**WSU3 – Replacing Air-Conditioning Compressor Shield Plate (Workshop Campaign)**

Vehicle Type: **Panamera 4 E-Hybrid (YAA/YAB)  
Panamera 4S E-Hybrid (YAA/YAB)**

Concerns: **Shield plate for air-conditioning compressor**

*Air-conditioning compressor shield plate installation position*

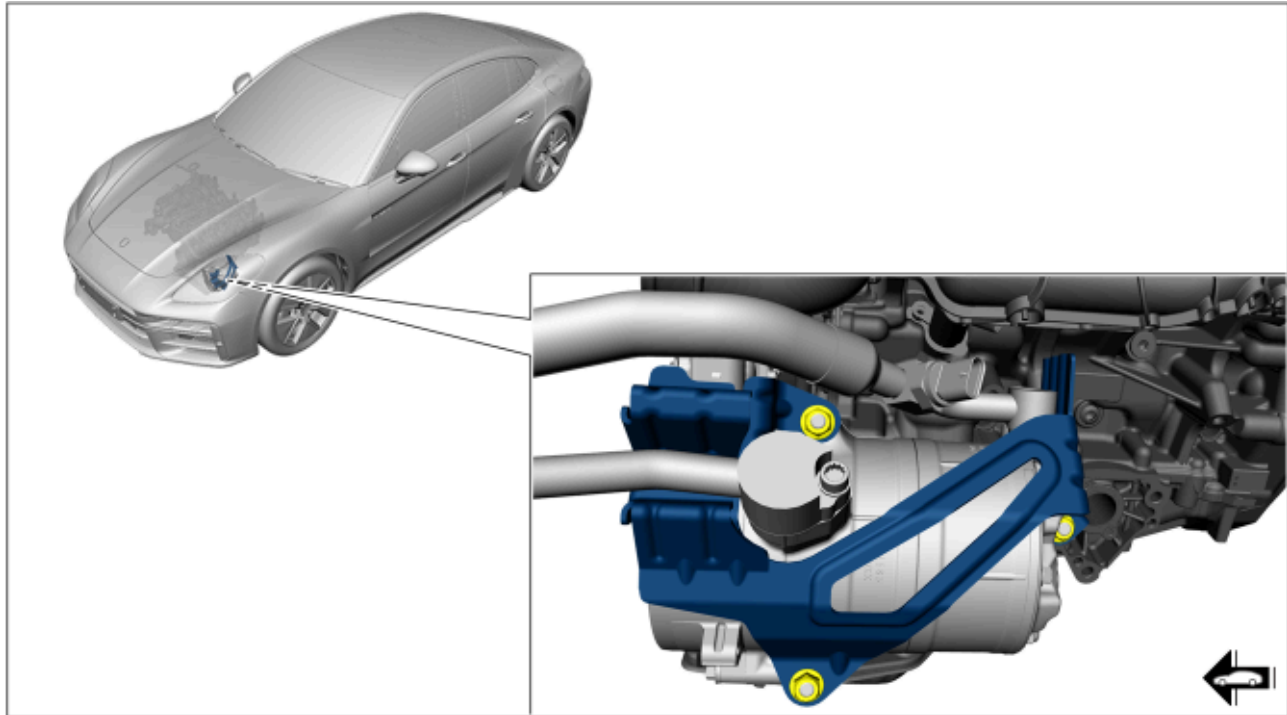
Information: **On the affected vehicles, there is the possibility that a shield plate was installed on the air-conditioning compressor with weld points that do not have the required strength.**  
In the event of an impact, the intended protective effect for the refrigerant lines cannot be fully guaranteed by the shield plate.

Action: replacing the air-conditioning compressor shield plate.

- Work Procedure: 1 Remove the electric air-conditioning compressor and install it **with the new shield plate**.  
 ⇒ *Workshop Manual '873419A1 Removing and installing electric air-conditioning compressor'*
- 2 Enter the campaign in the Warranty and Maintenance Logbook.
